KANATA LAKES
STORM DRAINAGE REPORT
CAMPEAU CORPORATION
ADDENDUM NO. 1

SEPTEMBER 1986

JOB NO. 86-5140

CLIENT	CAMPEAU CORPORATION		
PROJECT	KANATA LAKES		
TITLE	MINOR SYSTEM PLAN		
	 OLIVER MANGIONE McCALLA & ASSOCIATES LIMITED Consulting Engineers		
	Nepean Ontario		
DATE	FEBRUARY 1985	SCALE	1 : 5000
DRAWING NO.	84-4286-SW2	REV	1

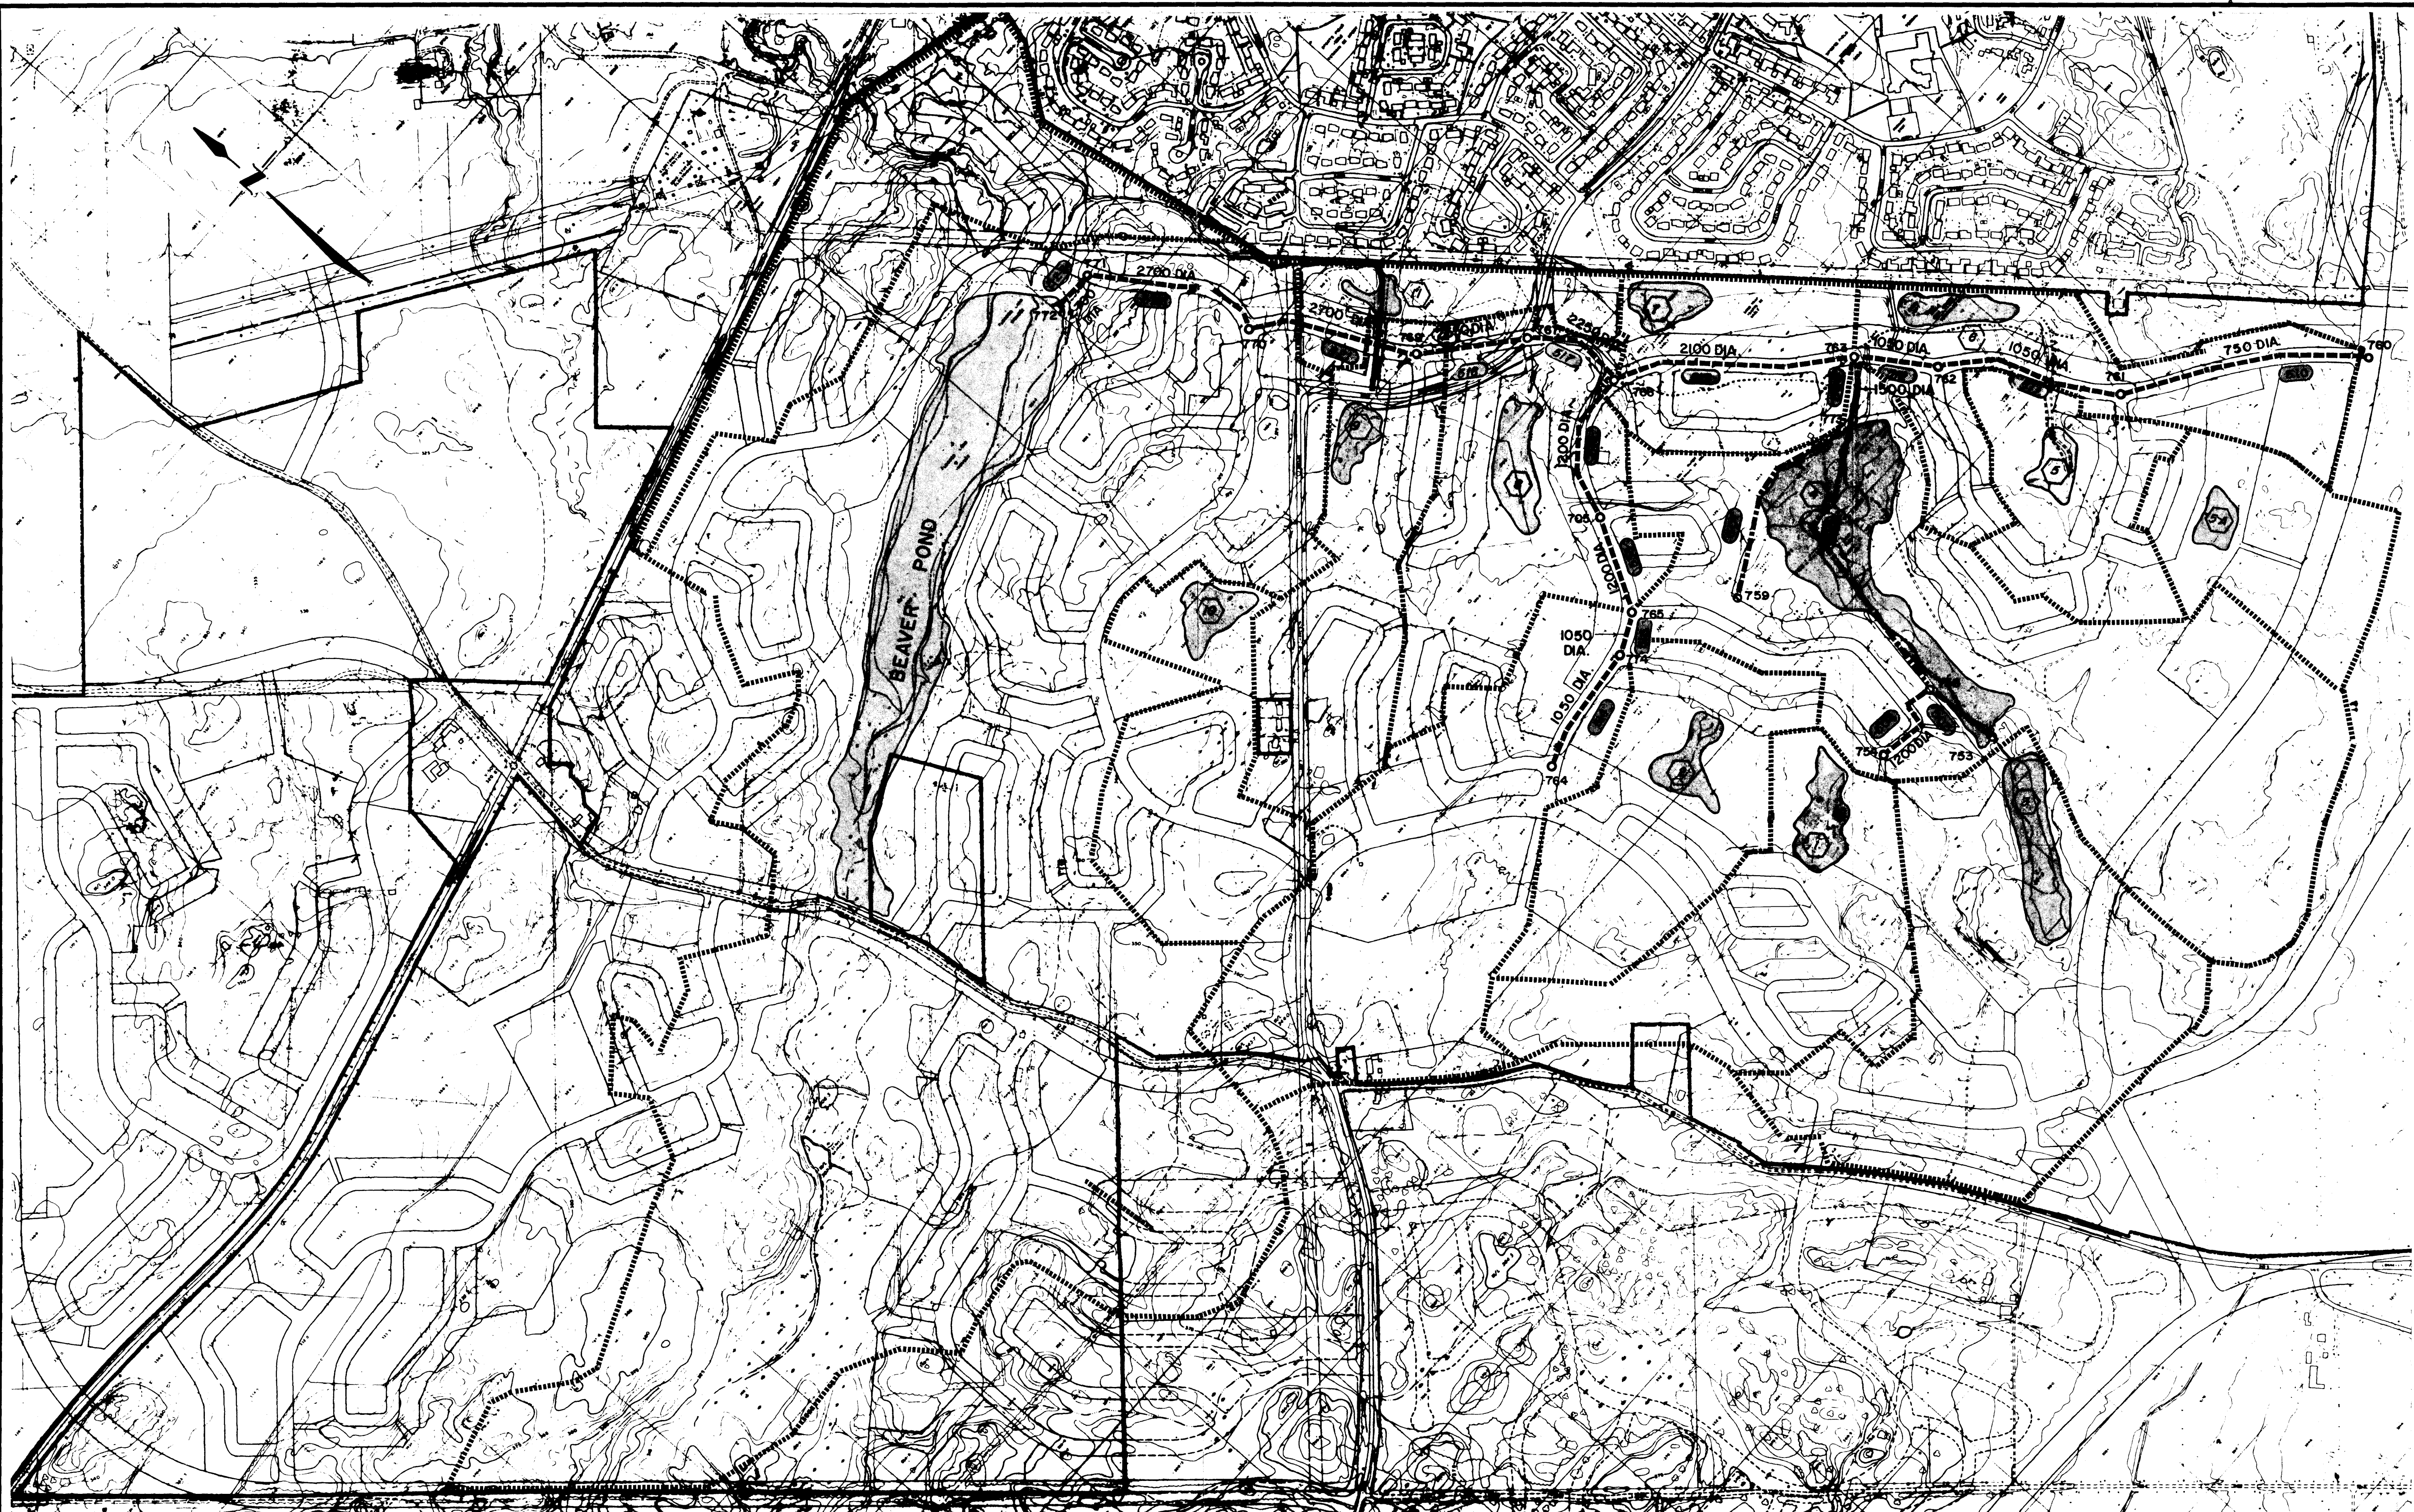
where is junction
778

impact on
Beaverbrook Road
plus Pond 6

what was the
previous discharge rate

DATE: DECEMBER, 1984
 SCALE: HORIZ: 1:2500 VERT: 1:50
 DRAWING No: 84-4286-SW4
 REV: 2

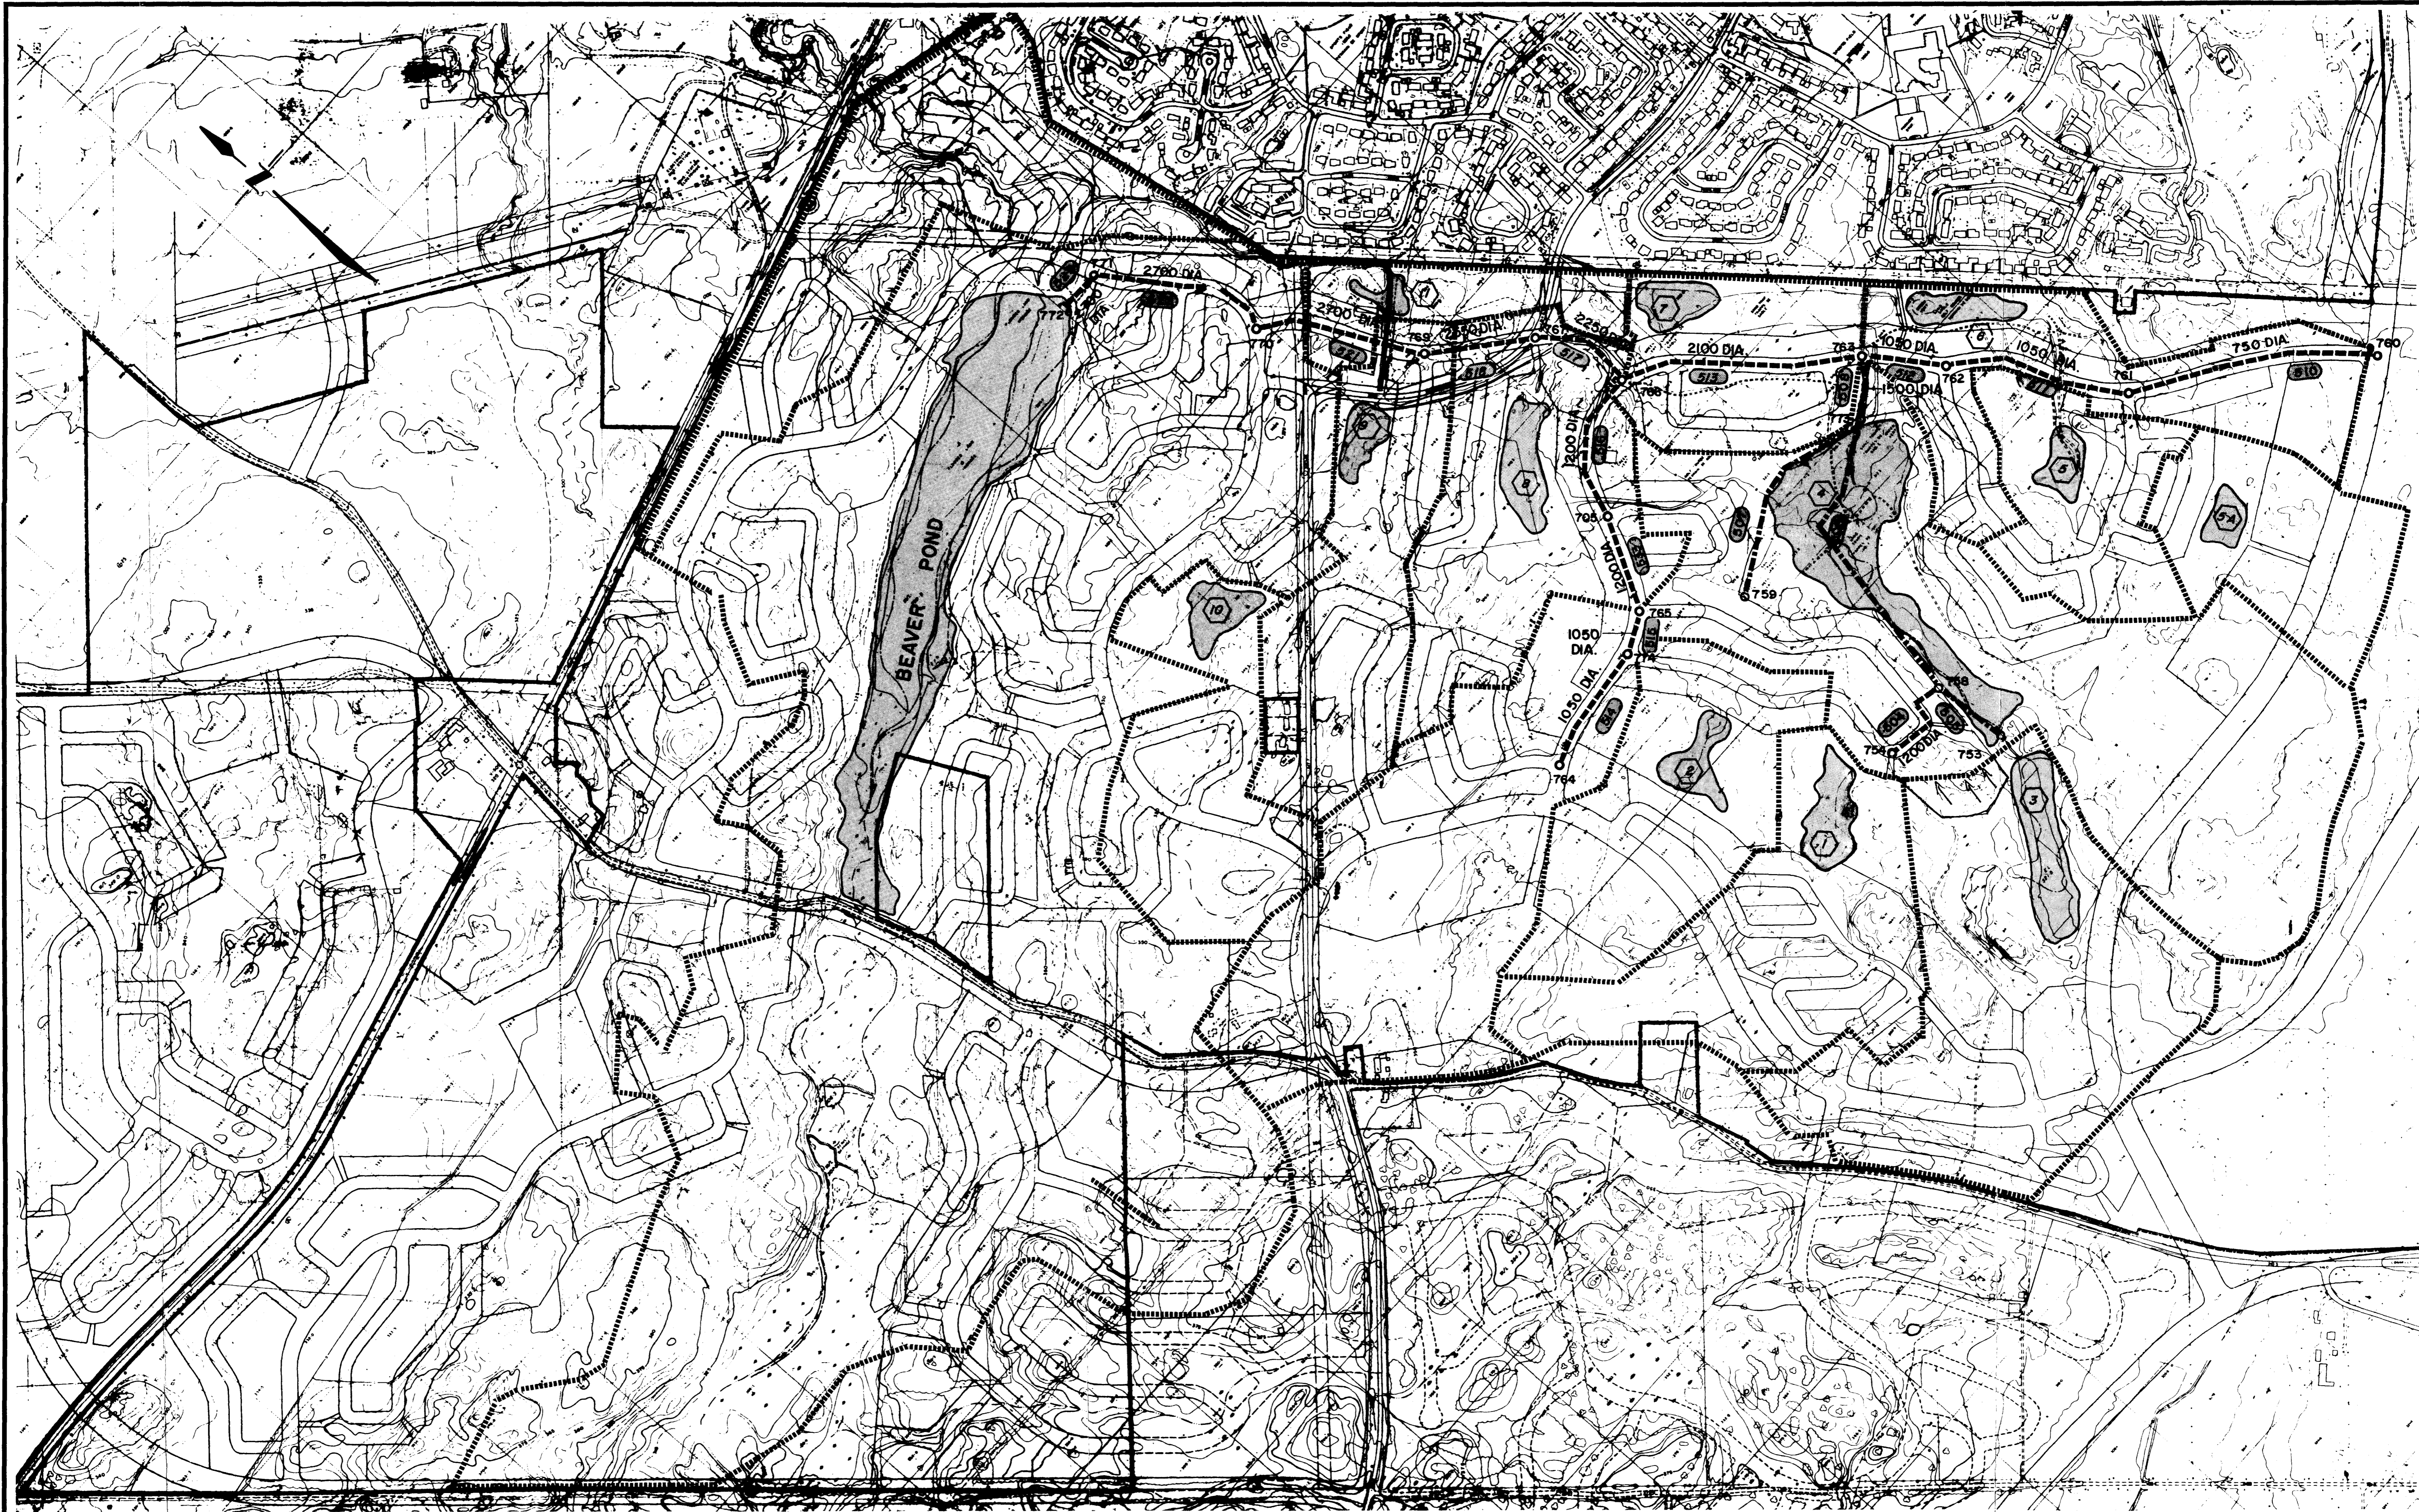
what effect does
3:1 side slopes make
